30-46 AUBURN ROAD, REGENTS PARK

Urban Design Review
Canterbury-Bankstown Council

Project Client: Canterbury-Bankstown Council
Project Name: 30-46 Auburn Road, Regents Park
Project Number: 0691 SYD

Proposed development by Stanisic Architects- Building Heights

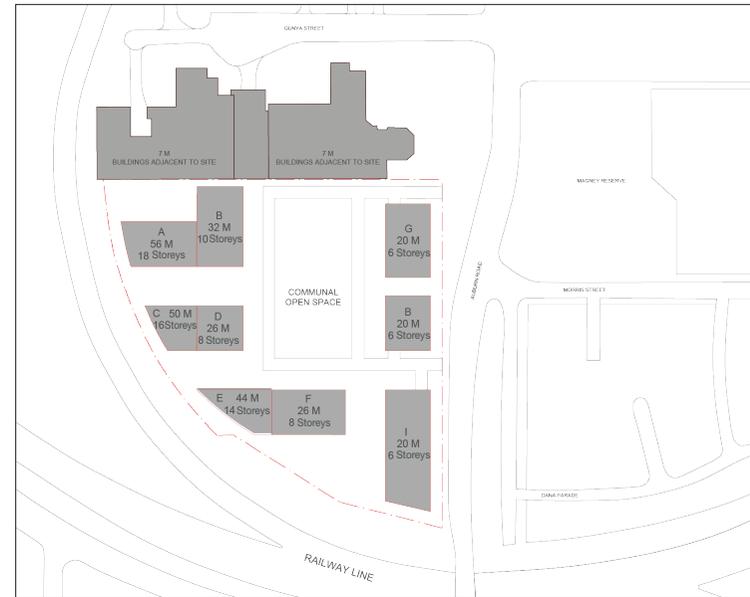
<p align="center">Built Form</p>	<p>The built fabric pattern of the precinct will result in a Small Village Centre, consisting of buildings creating legible overall urban form, with corresponding public spaces servicing the recreational and social needs of the residents. While buildings are expected to be generally of a similar height it is also expected that the urban neighbourhood will be composed of a diversity of building forms and corresponding architectonic expression.</p>	<p>The proposal IS a dense urban composition, with proposed building heights within a close range of 6 to 8 storeys. While the proposal indicates building massing only, the forms, unit layouts, ground floor uses and deployment on the site and relative to the street suggest a single typology, rather than a diversity of forms. The building layout creates a precinct focussed on narrow streets, typical of a portion of a dense urban fabric, rather than developing the spatial sensibility of a village centre, as characterised by the surrounding residential grain around Magney Reserve. This deployment of the built form results in streets as public space, which are of limited utility, while also receiving limited solar access. The shadow and solar diagrams in the Appendix illustrate these limitations.</p>

Proposed development by Stanistic Architects - Solar access to communal open space

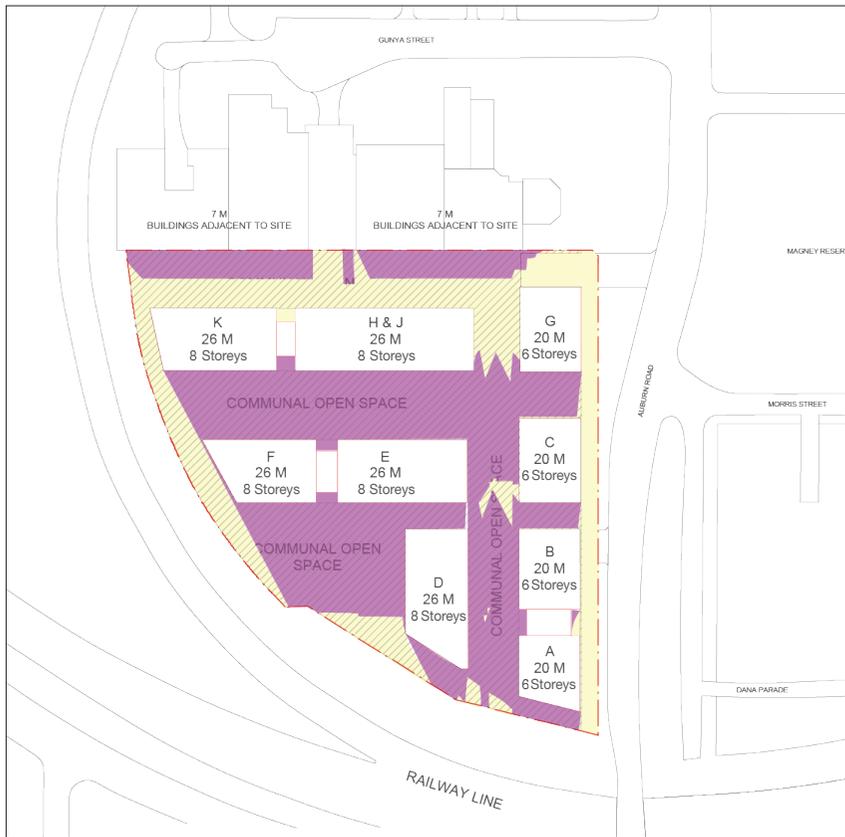
The current proposed scheme performs poorly in the provision of open space, in terms of its scale, utility and solar access. Any suggested increases in floor space to the current scheme (which could only be realised through increased height) would further exacerbate the impacts on solar access to the public spaces, while placing additional pressures on the network of small-scaled spaces nominated within the proposal. Thus, with the existing layout, the suggested bulk and scale of the built form creates most of the poor performance, in terms of open space amenity. However, other limitations would still remain were the bulk and scale to be reduced, including the orientation of the major open space, and the limited social utility of the streets proposed as public space.
